NORTHEAST UTILITIES

June 14, 1984

Docket No. 50-423

Millstone Nuclear Power Station, Unit No. 3
Additional Information for Question 492.6
and Draft SER Open Items CPB-3 and ICSB-14

FIGURE 4.4.-11

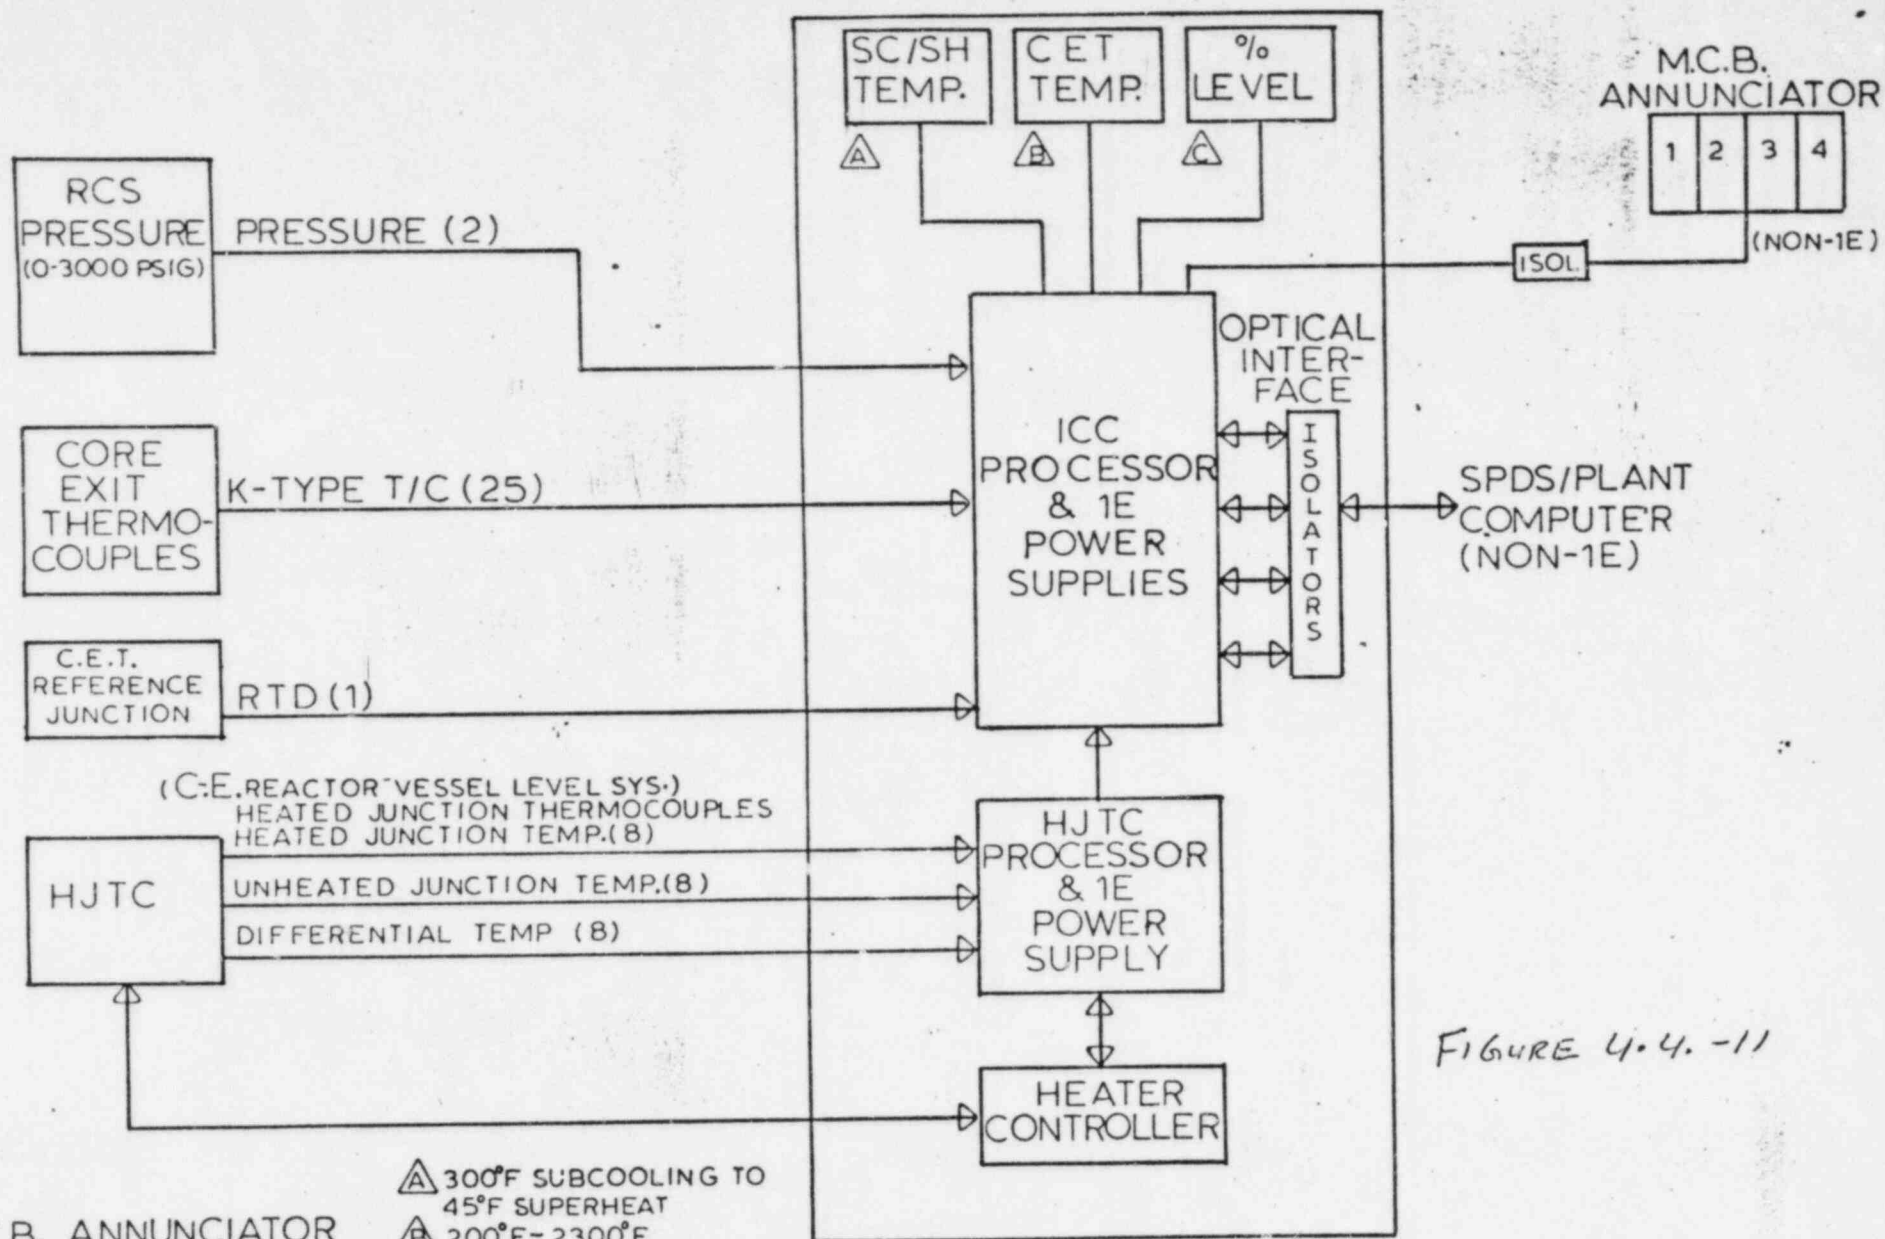
The staff has reviewed the Applicant's submittal (FSAR Section 4.4.6.5) with respect to NUREG-0737 Item II.F.2 requirements and has found that the Applicant's submittal is incomplete. Therefore, the staff will require the Applicant to provide the documentation required by Item II.F.2 of NUREG-0737 for staff review.

The information provided by this system allows the plant operators to monitor the reactor status during abnormal plant conditions. The operator uses this information to take corrective action as needed and/or confirm that actions taken produce the desired result. Thus, the approach to, existence of, and recovery from inadequate core cooling conditions can be monitored consistent with the requirements of NUREG-0737, Section ILF.2. The Millstone Unit No. 3 ICC System is designed as Category 1 (Class 1E) with redundant trains (train A and train B). Each train contains stand alone processing electronics and displays, which monitors, alarms, and trends ICC, as shown in FSAR Figure 4.4-11.

Each ICC cabinet (train A & B) has a qualified class 1E display system that includes the following ICC information:

1. Subcooled/Superheat in °F (300°F Subcooling to 450°F Superheat)
2. Core exit temperatures (200°F to 2300°F).
3. % Level in the plenum and head areas.

The primary means of displaying all the ICC information is provided via the Safety Parameter Display System (SPDS). SPDS will receive all the ICC transmitted data with optical isolation provided by ICC. SPDS will have the capability to calculate Subcooling/Superheat based on primary coolant

temperatures, T_{hot} , T_{cold} , CET, unheated junction temperatures of HJTC, and RCS pressure. Signal Validation techniques are utilized in the SPDS to insure the quality of the input variables. SPDS displays are designed to incorporate accepted human factors principles so that the displayed ICC information can be readily perceived and understood by plant operators during normal and abnormal plant conditions.

Alarms are provided on Main Control Boards from the ICC Cabinets. There are four alarms, saturation/superheat trouble alarm, CET high alarm, plenum % level alarm, and head % level alarm.

FIGURE 4.4-10
DISTRIBUTION OF INCORE
INSTRUMENTATION
MILLSTONE NUCLEAR POWER STATION
UNIT 3
FINAL SAFETY ANALYSIS REPORT

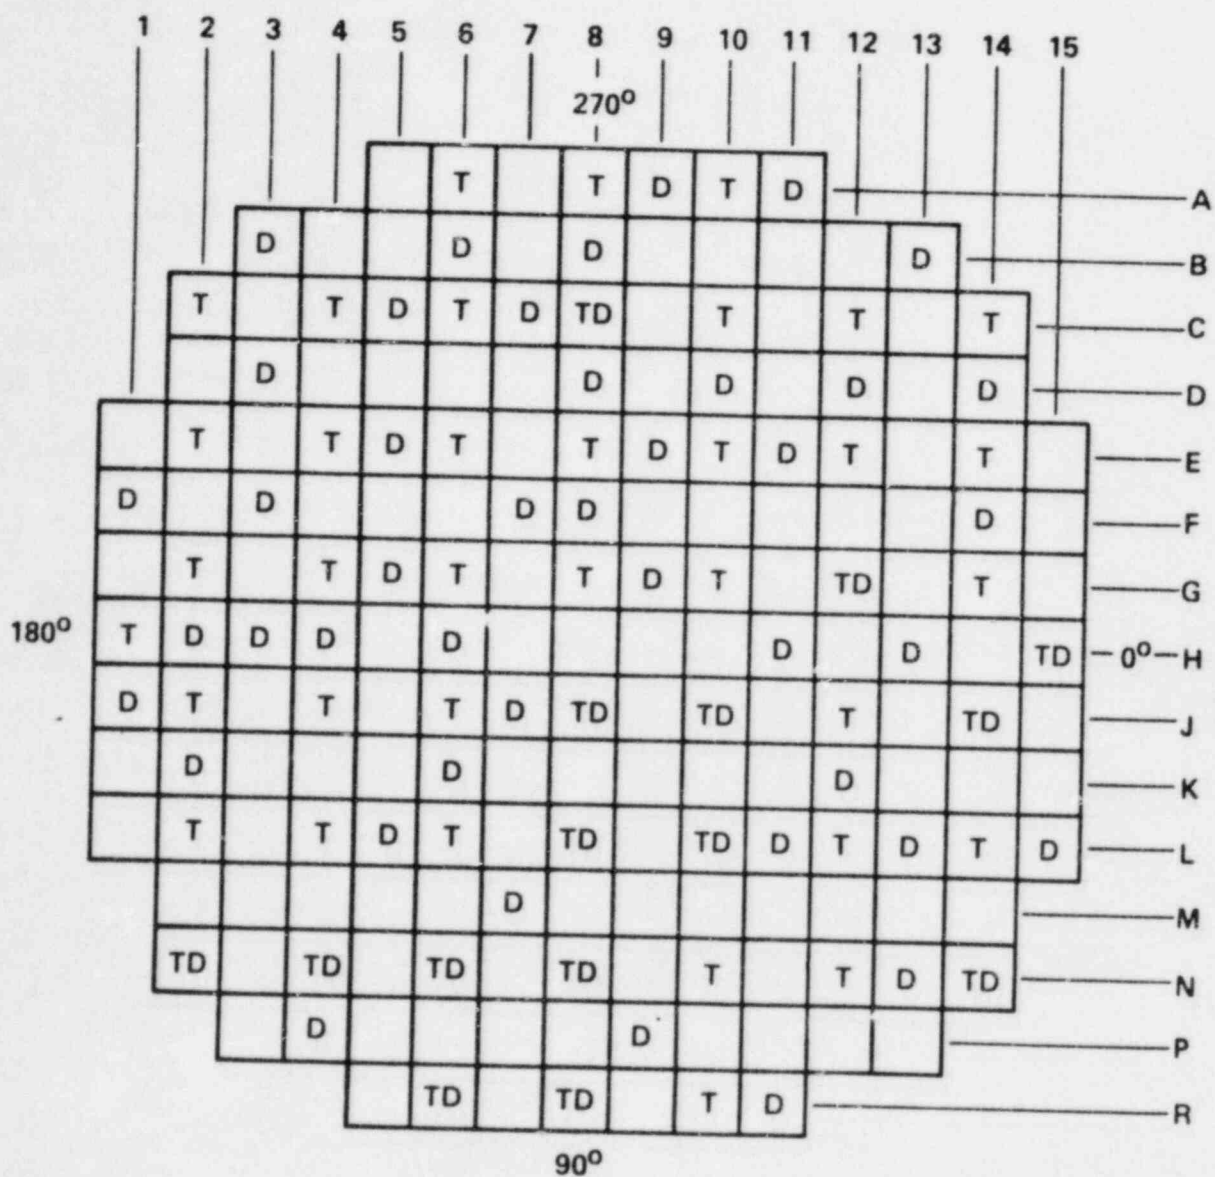
- I. Provide diagram of core exit thermocouple locations or reference the generic description if appropriate.

Refer to FSAR Figure 4.4-10 (Attached)
